June 29, 2011

**Re: Proposed Project to  
Build a Hydro-electric Generating Station at the North Bala Falls**

Figure 1 – Rendering Inaccuracies

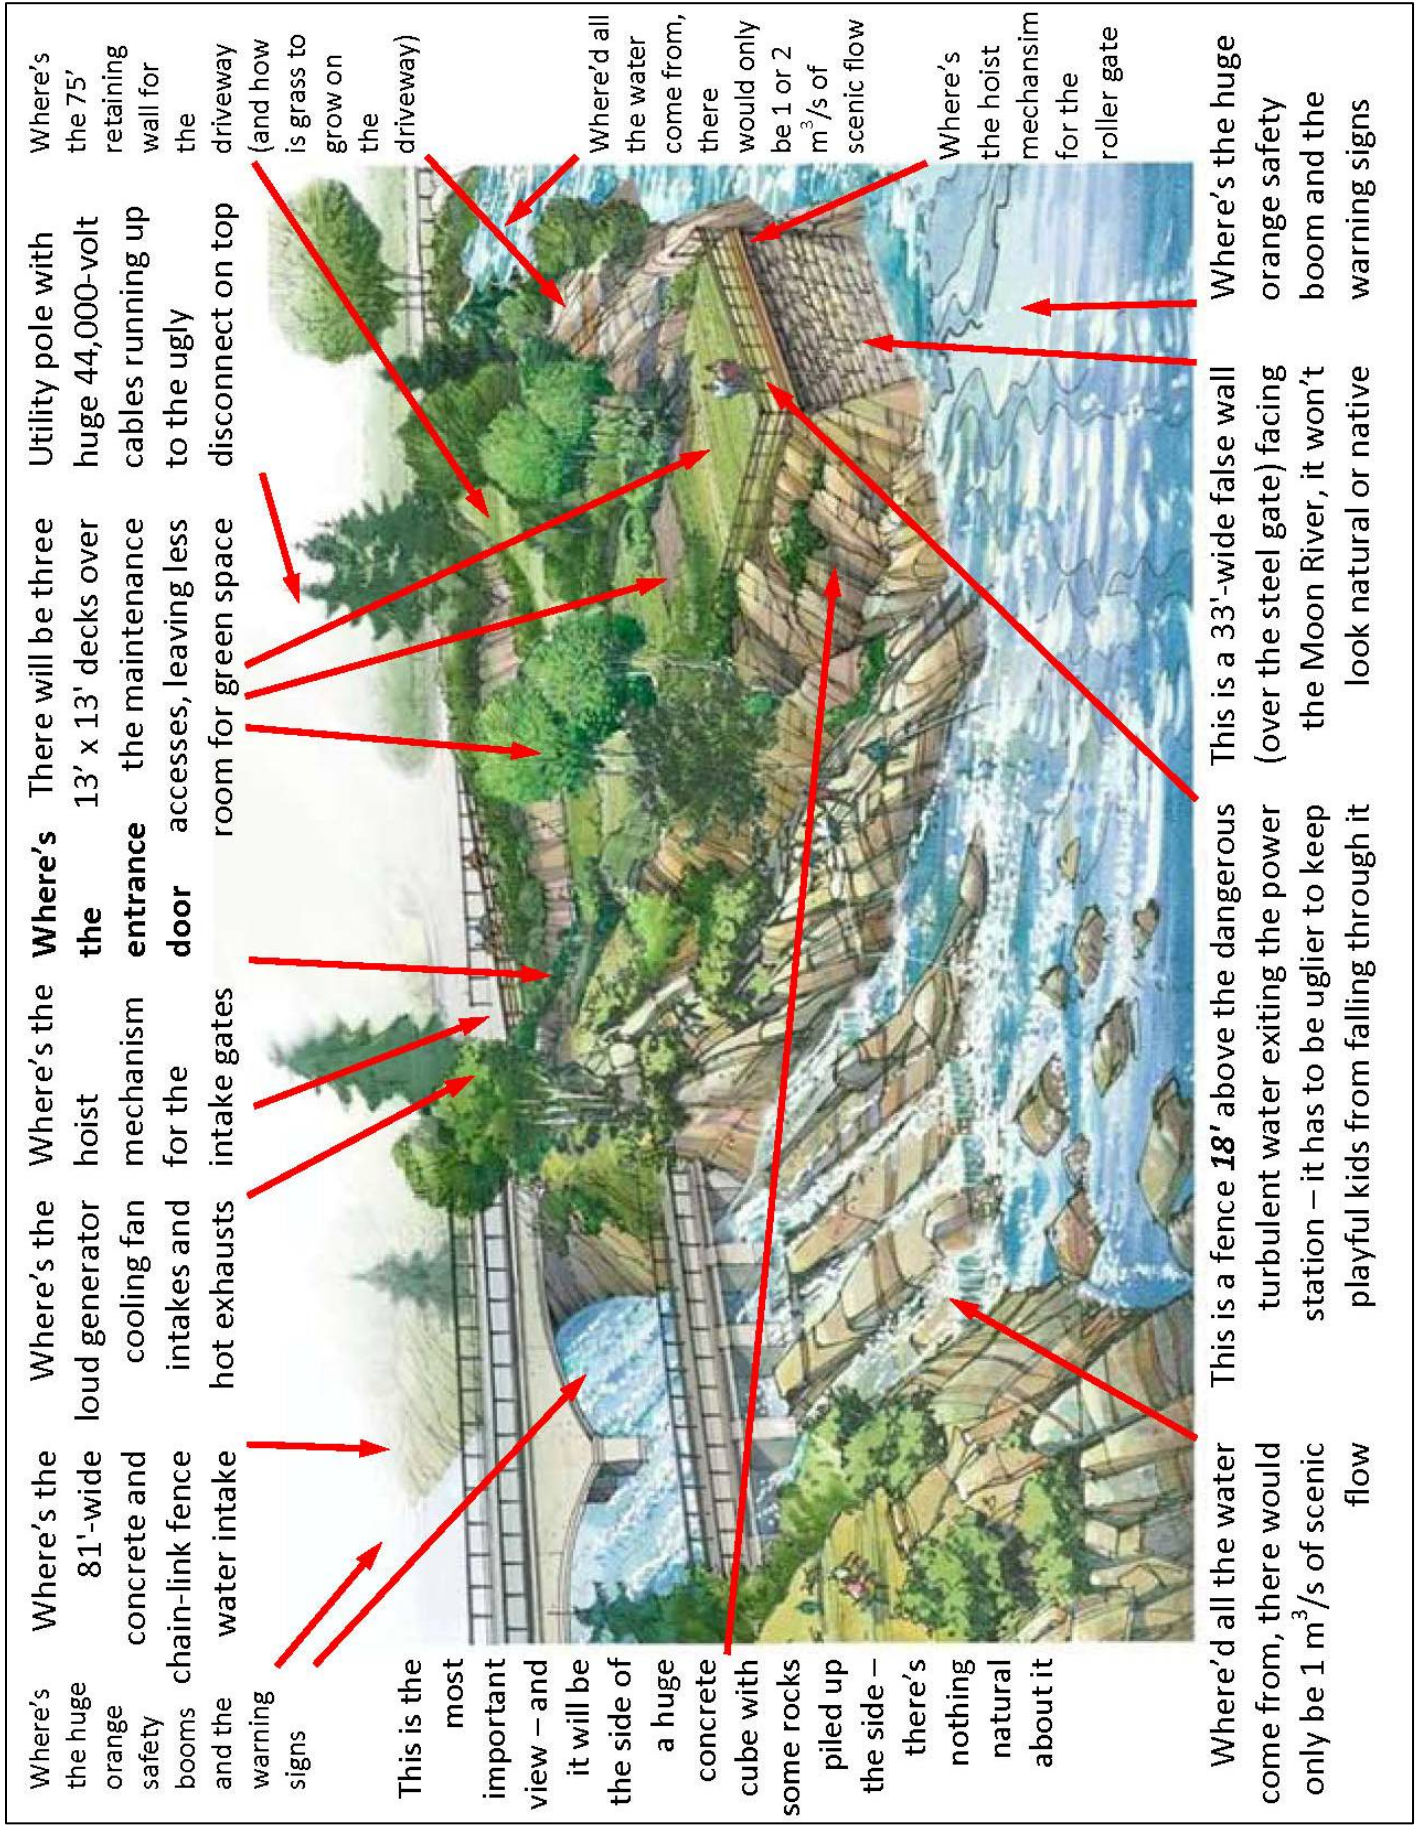
The Ministry of the Environment notes the public's concern, but the proponent's October 25, 2010 reply states "*The public comments on the rendering were that it was not exactly to scale.*" **This is not true.** As described below, the proponent knows the widespread and long-standing complaints that the renderings provided (even to date) have inaccuracies, for example:

- a) Years ago I personally spoke with the proponent's project manager about the numerous errors and oversights of the rendering, who replied: "*Mitchell, you're not the first – you're not the tenth person to note this*".
- b) For more than two years we have made our concerns about the proponent's rendering known in detail; by posting a marked-up version (see Figure 1) of the proponent's rendering posted on our web site, presented at District Council meetings (<http://savethebalafalls.com/?p=2583>) at which the proponent was

- c) Furthermore, we have clearly stated to the proponent – in person – that our concerns are **not about mere landscaping**. But the proponent's e-mail shows the only input they may accept from the public would be just landscaping (and note that the proponent recently insisted on, and received complete control over the "*membership, mandate, agenda, and presentation material*" for the flow distribution committee and yet they still wrote the MoE to completely ignore the work of this committee – why should the public believe even their landscaping input would be accepted either).

The public needs to know what is **under** the landscaping. For example, at one early point in the project the proponent planned that the proposed station's personnel door would be at the bottom of an exposed stairwell into which trash – and children – could fall.
